Belmont Drought Response Desalination Plant (SSI-8896) DPIE Request for Additional Information - 03022021

We refer to the DPIE request for additional information dated 3 February 2021 in relation to the Belmont Drought Response Desalination Plant planning application. Hunter Water's response to the request for additional information is provided below:

Figure 1 Laydown and storage area

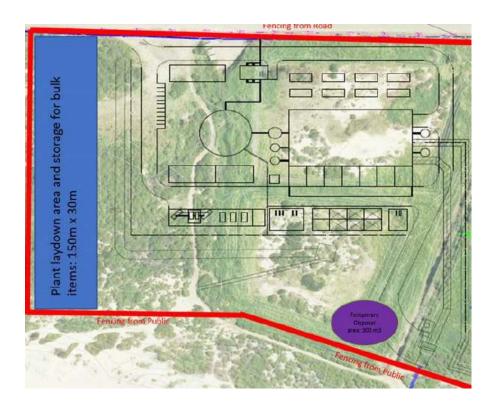
2. Detail of where excavated materials will be stored, including those associated with any excavations of the sea bed

The spoil management principles for the Project are to beneficially re-use excavated material on site as far as practical. Spoil management plans are to be developed during detailed design. An area of 150m x 30m has been identified at the southern end of the site. This area is shown in **Figure 1**.

This area of 4,500 m² would be used to temporarily store excess spoil and bulk items during construction. Where beneficial re-use on site is not practical, excess spoil would be disposed off-site in accordance with waste management legislation.
